FED. ROAD DIST. NO.	STATE	PROJ. NO.	FISCAL YEAR	SHEET NO.	TOTAL SHEETS
HAWAII	HAW.	I-H3-1(72)	1991	C.O. ADD. 7	521

TYPICAL ROADWAY SECTIONS
H3 KANEHOE INTERCHANGE

INTERSTATE ROUTE H-3
F.A.I. PROJ. NO. I-H3-1(72)

**TYPICAL RAMP
SECTIONS AND DETAILS**

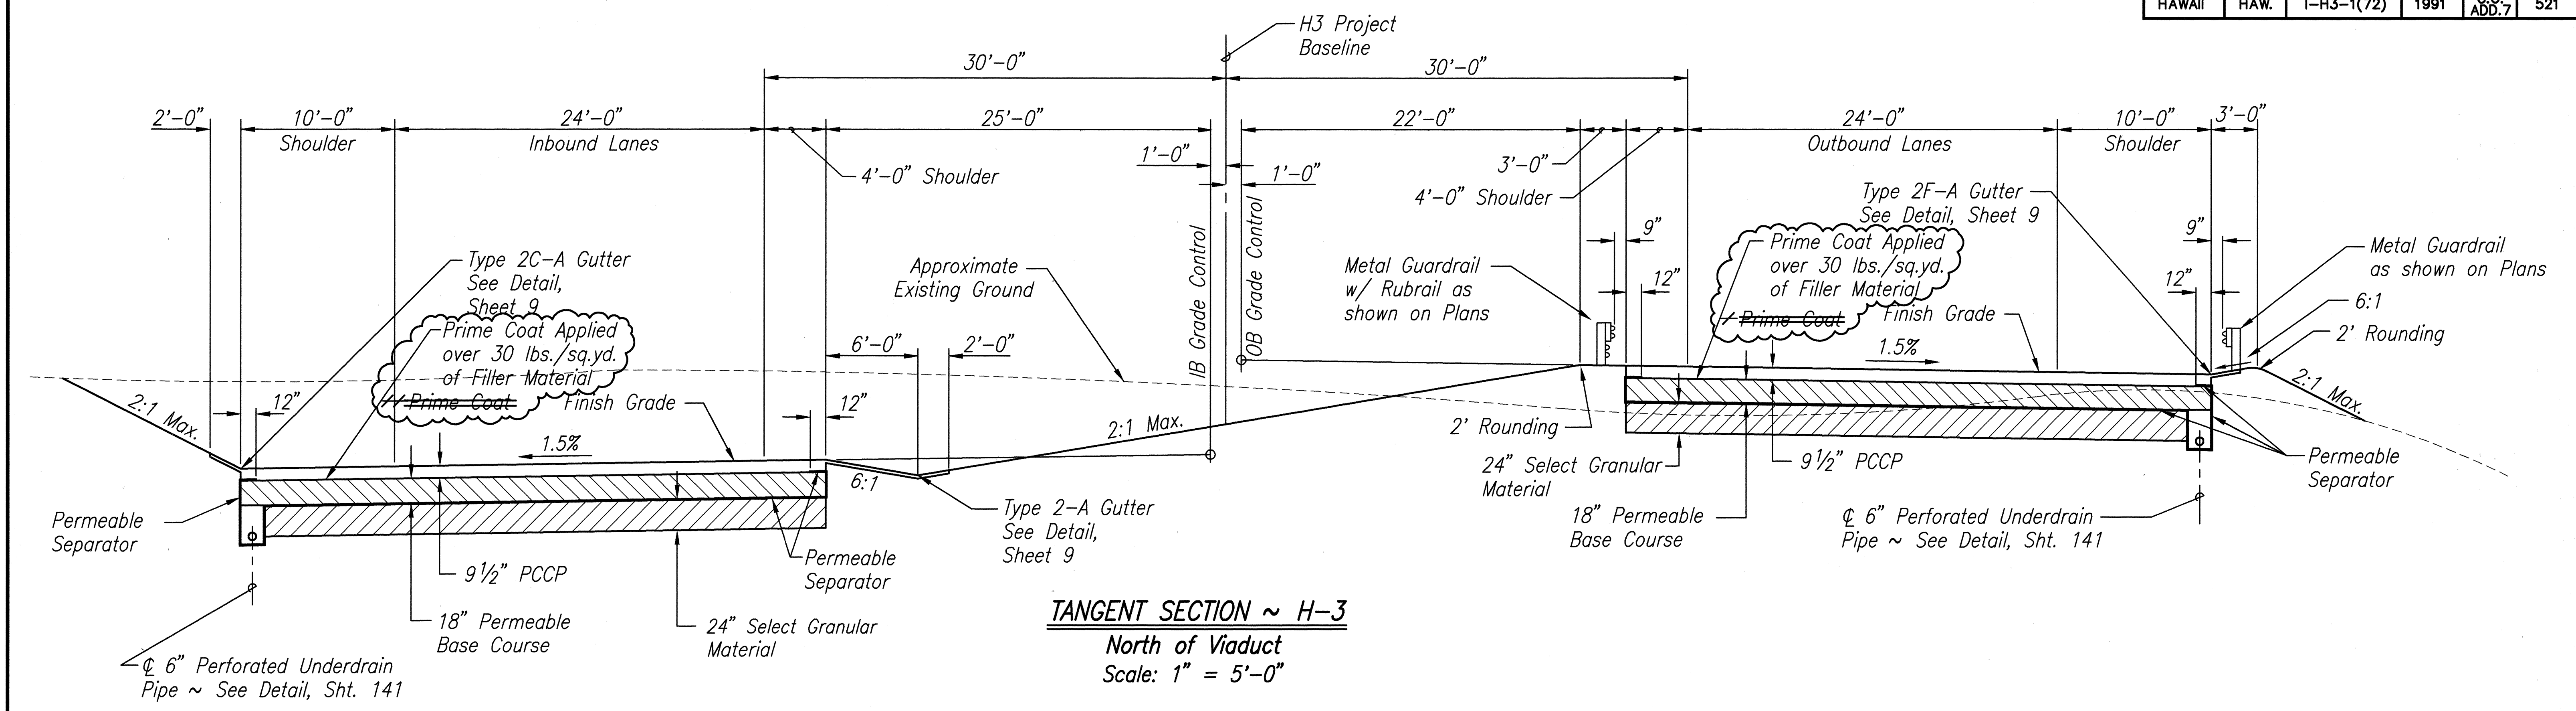
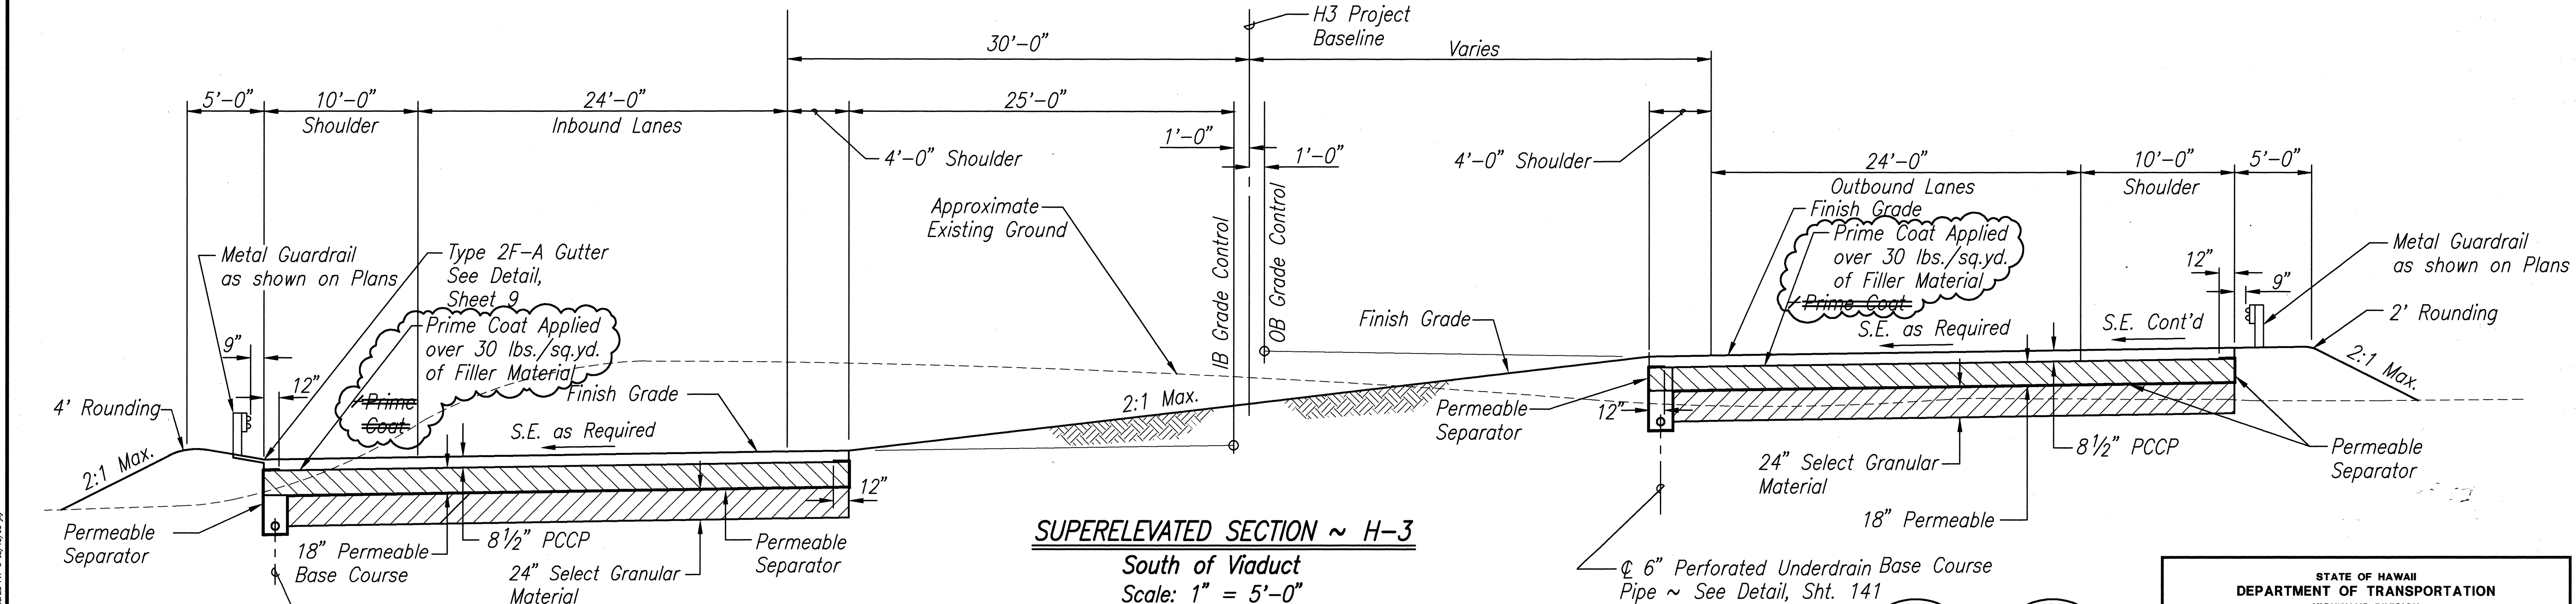
2/15/95	Added 30 Lbs./Sq. Yd. of Filler Material Over Permeable Base Course.
4/21/94	Deleted Conc. Guardrail (Type A) & Gutter (Type 2). Revised Median of Superelev. Sect.
3/27/92	Added item no. 4 to Notes.
2/21/92	Moved underdrain to lower side of roadway. Weep Hole & Filter Mat'l for Type A Guardrail shall be for inbound lane only. Added metal guardrail and guardrail callout.
1/27/92	Revised sta. reference to North and South.
DATE	REVISION

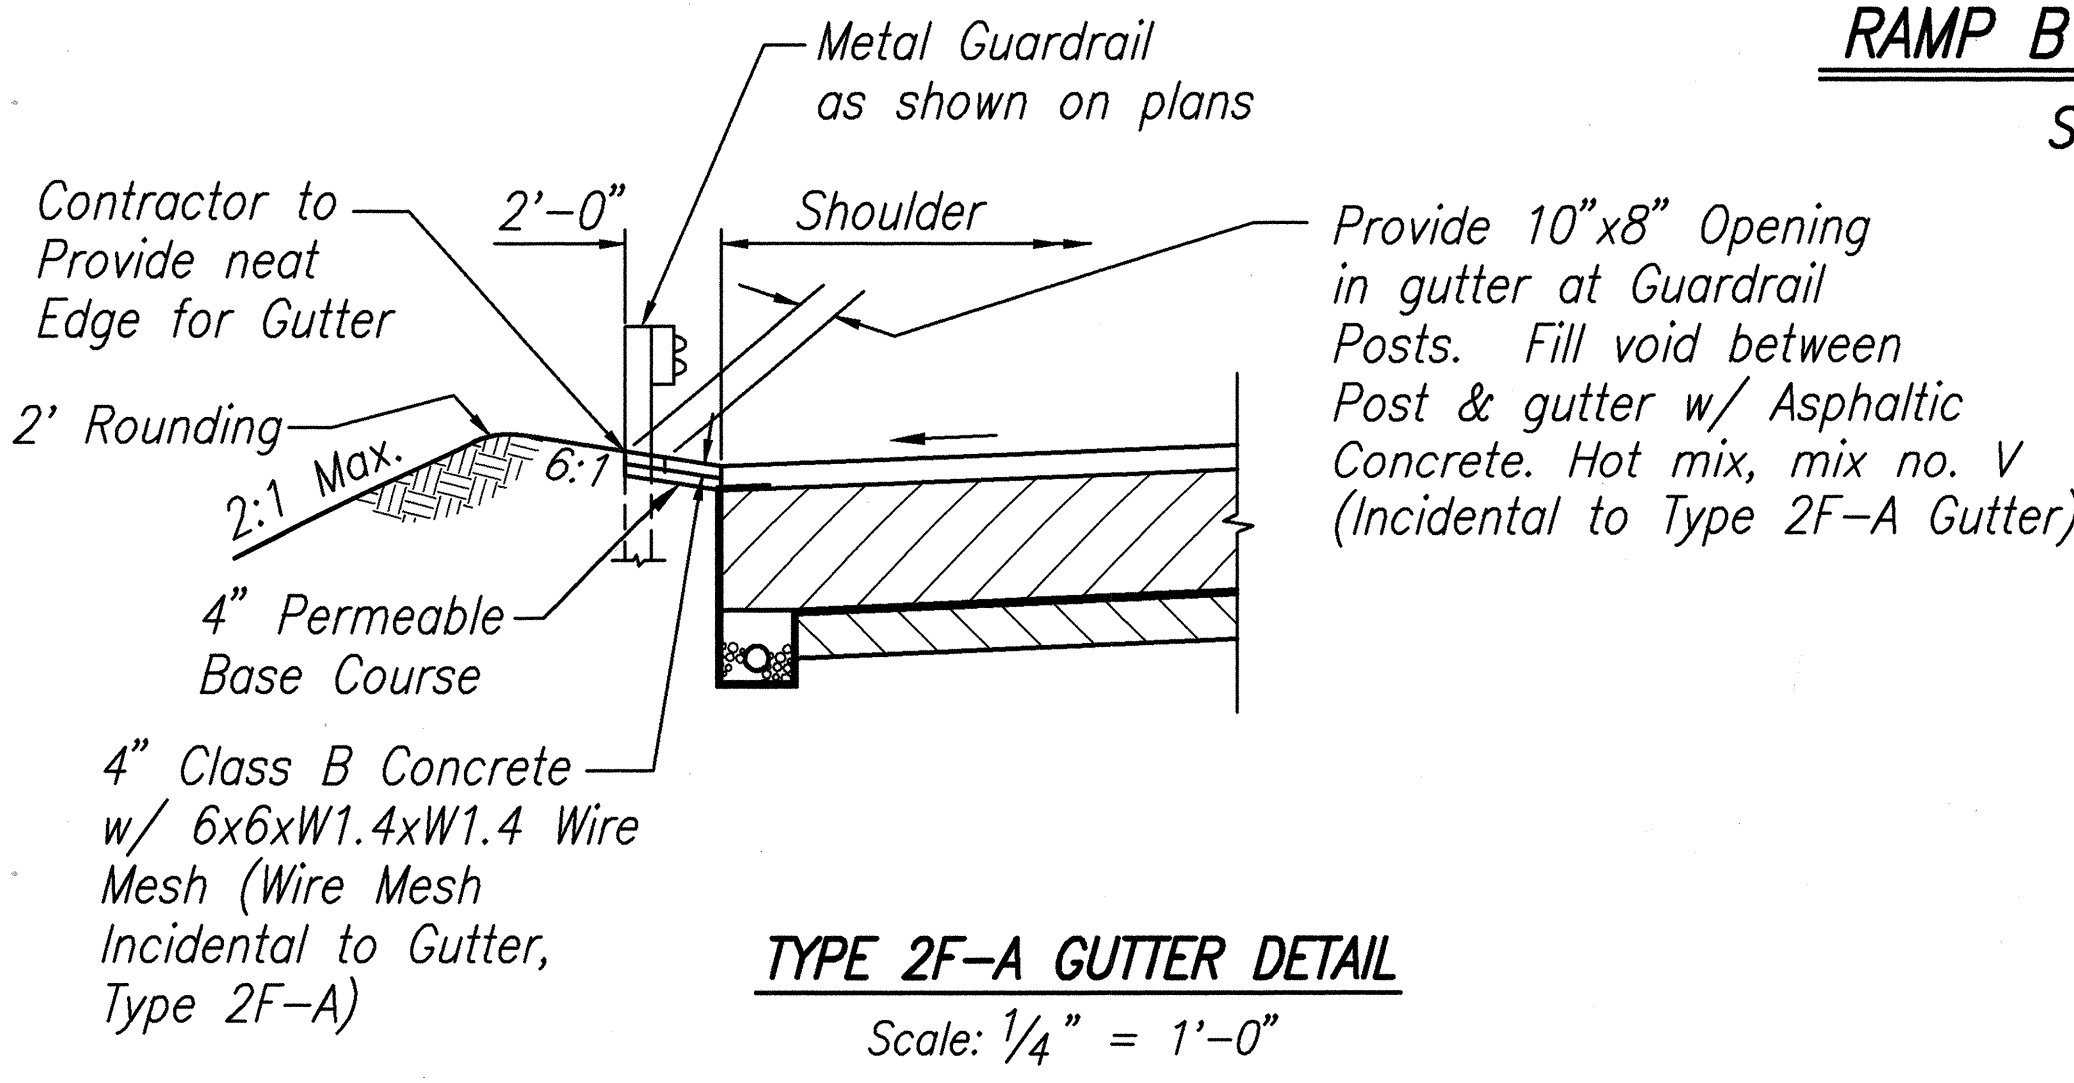
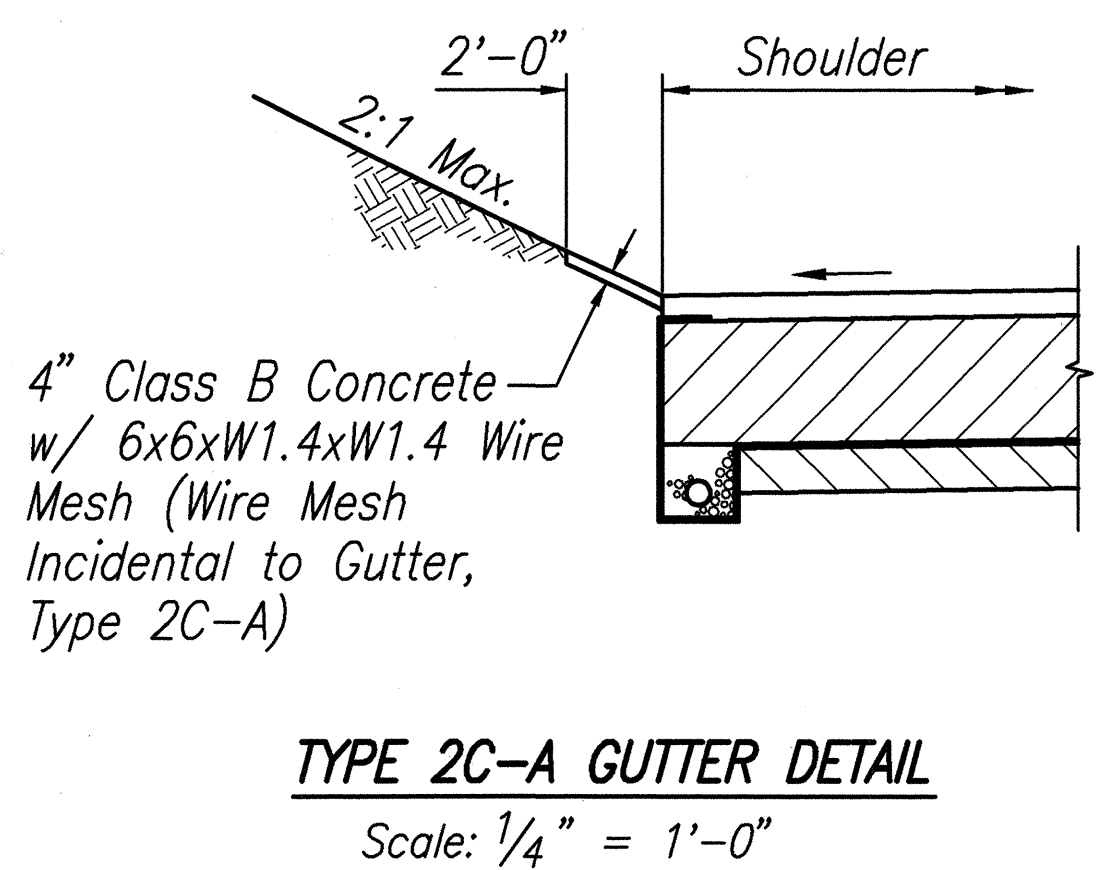
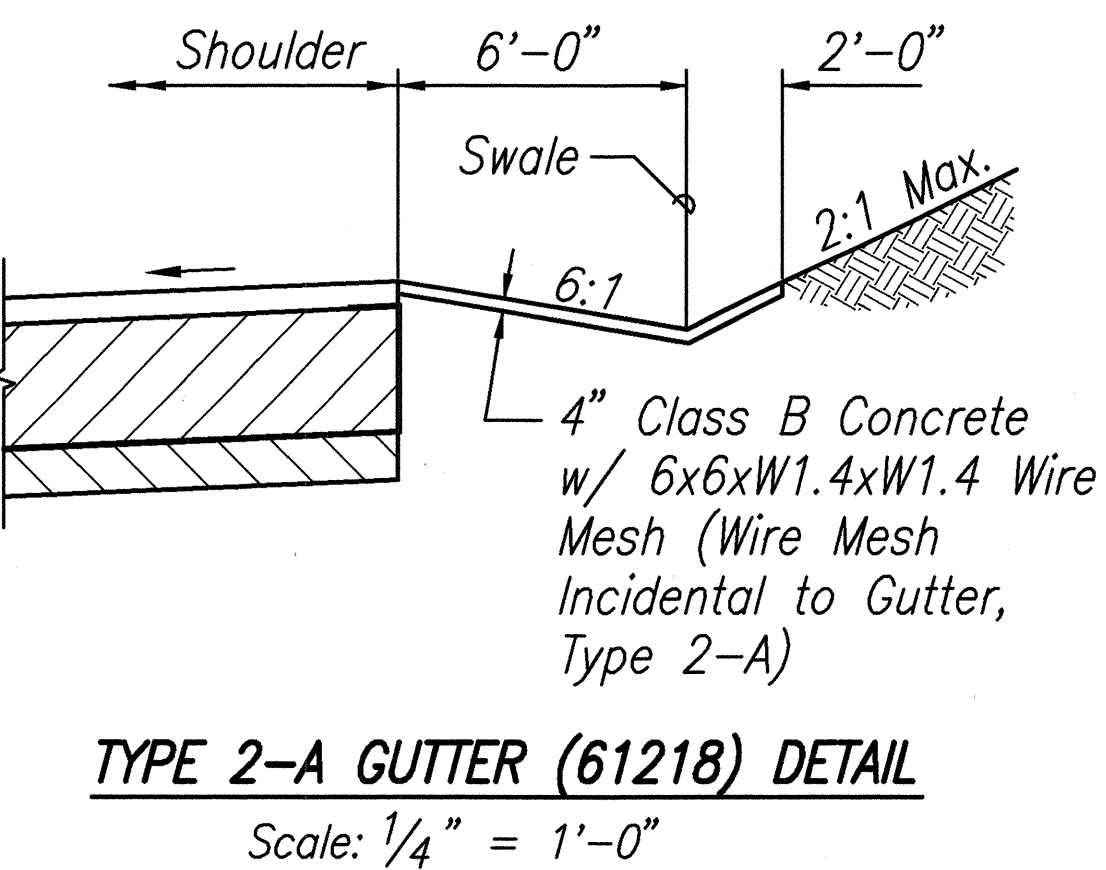
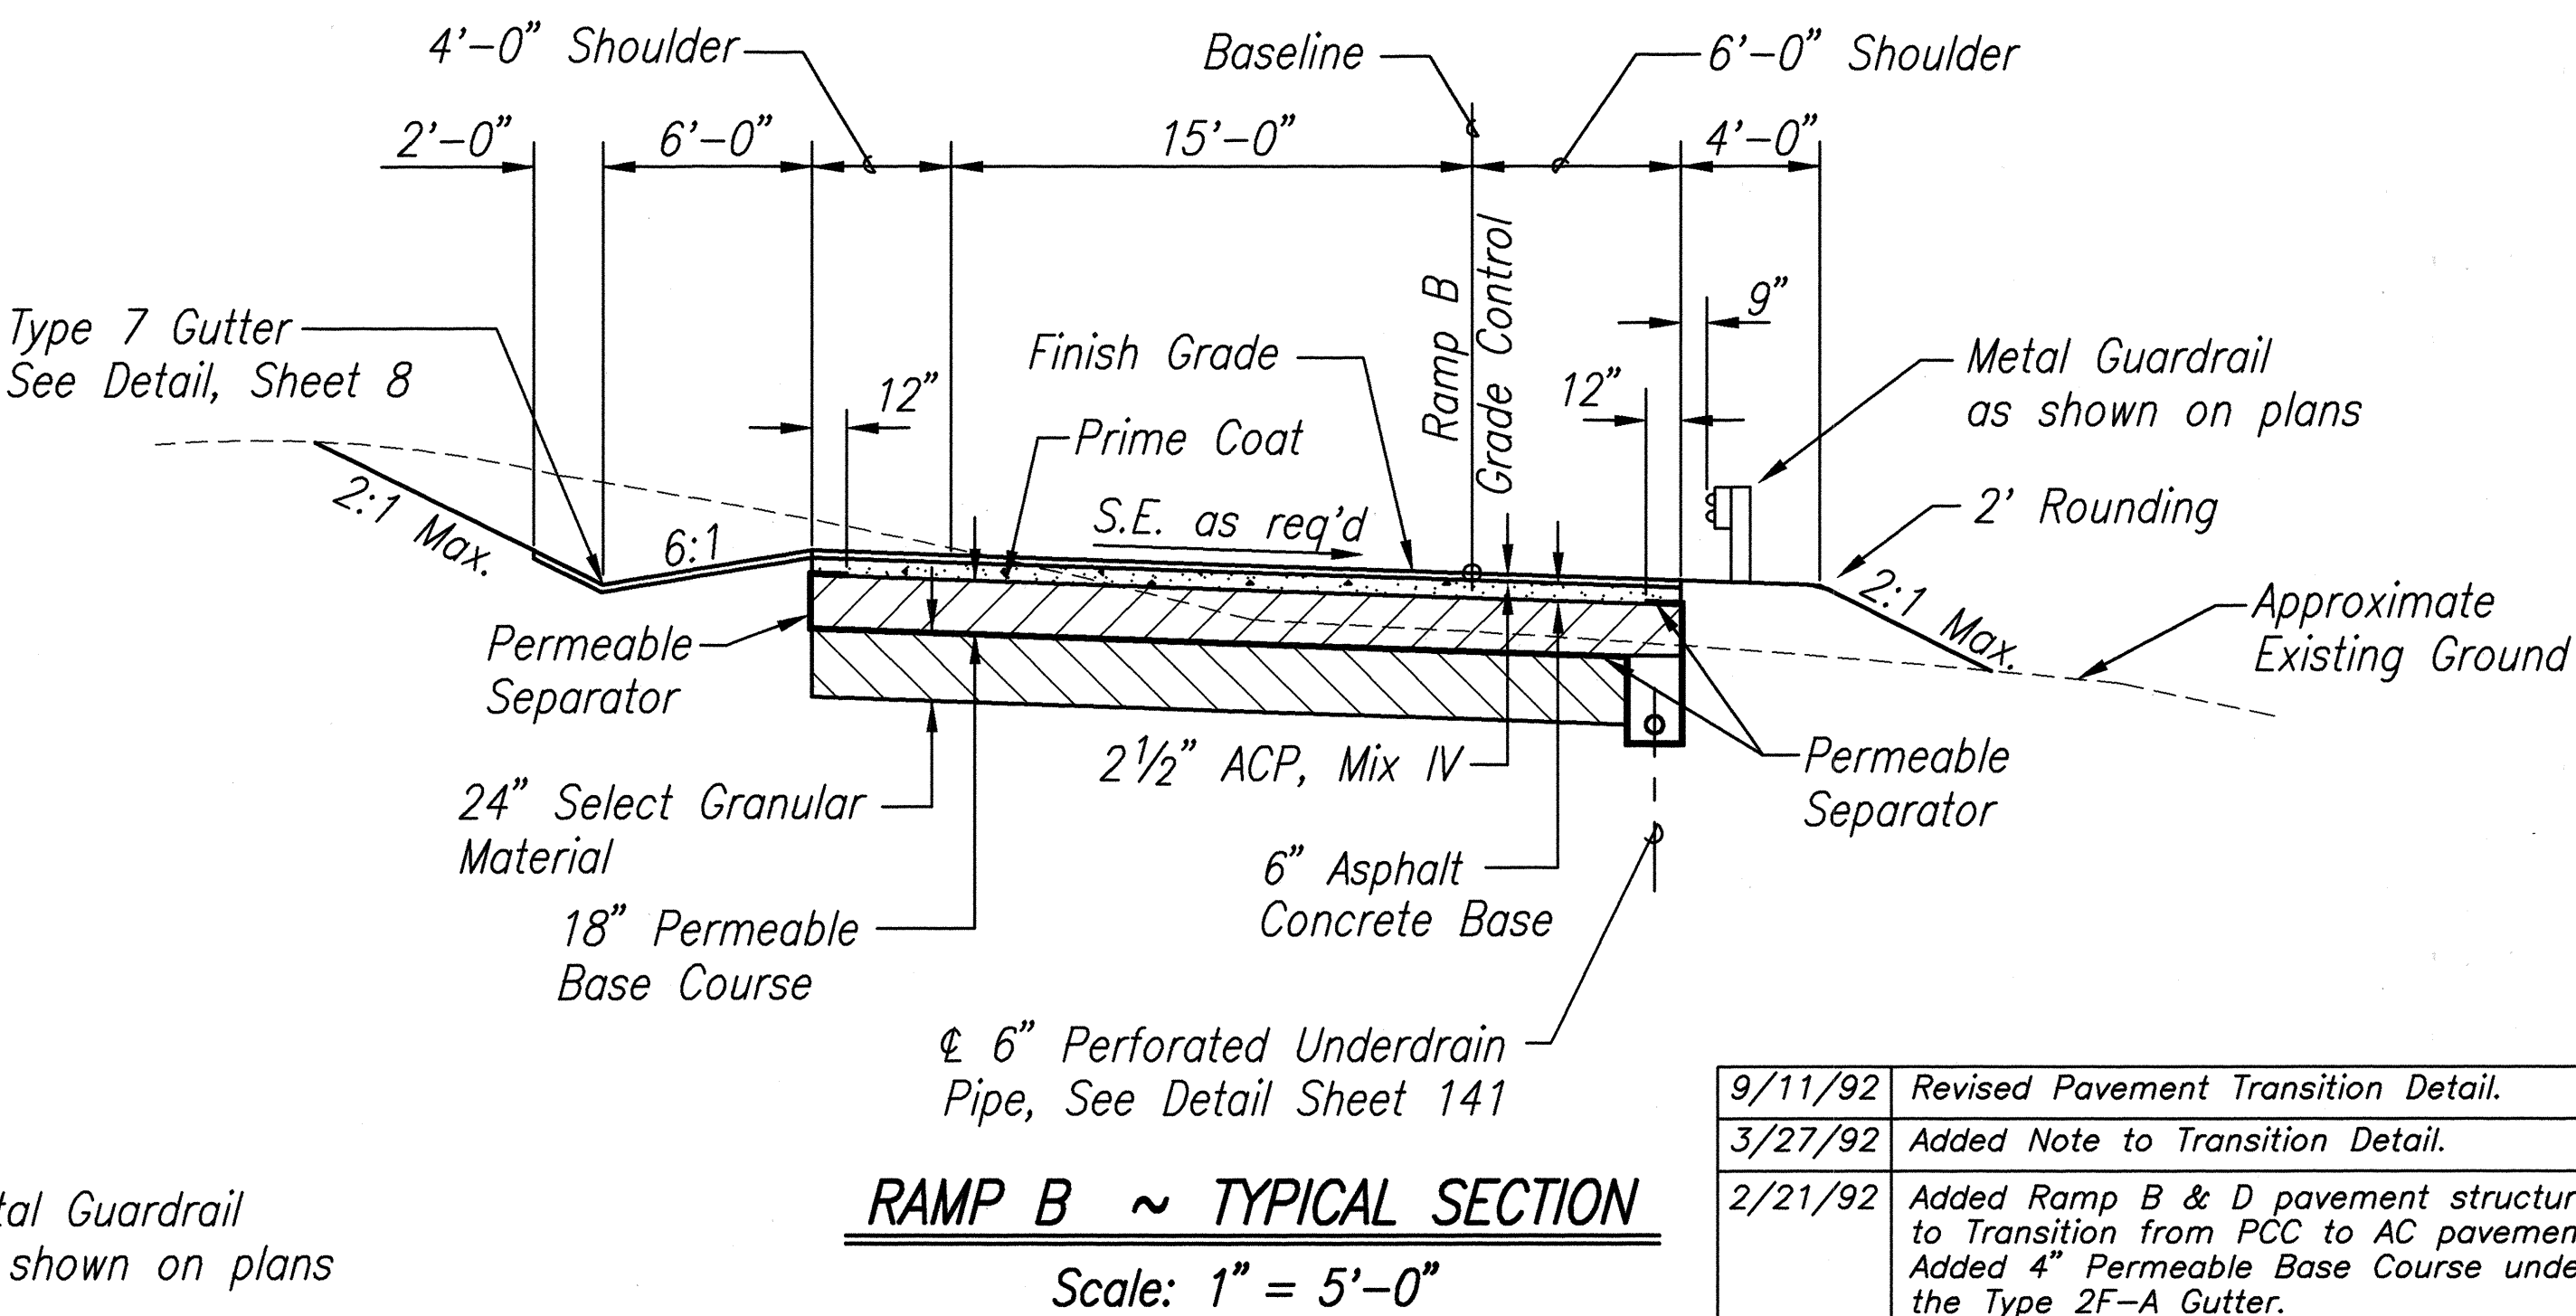
9/11/92	Revised Pavement Transition Detail.
3/27/92	Added Note to Transition Detail.
2/21/92	Added Ramp B & D pavement structure to Transition from PCC to AC pavement. Added 4" Permeable Base Course under the Type 2F-A Gutter. Void between post & gutter of Type 2F-A gutter shall be filled w/ hot mix, no. V.
1/27/92	Revised Type 2 Gutter to Type 7 Gutter. Added Metal Guardrail callout to Type 2F-A Gutter Detail.
DATE	REVISION
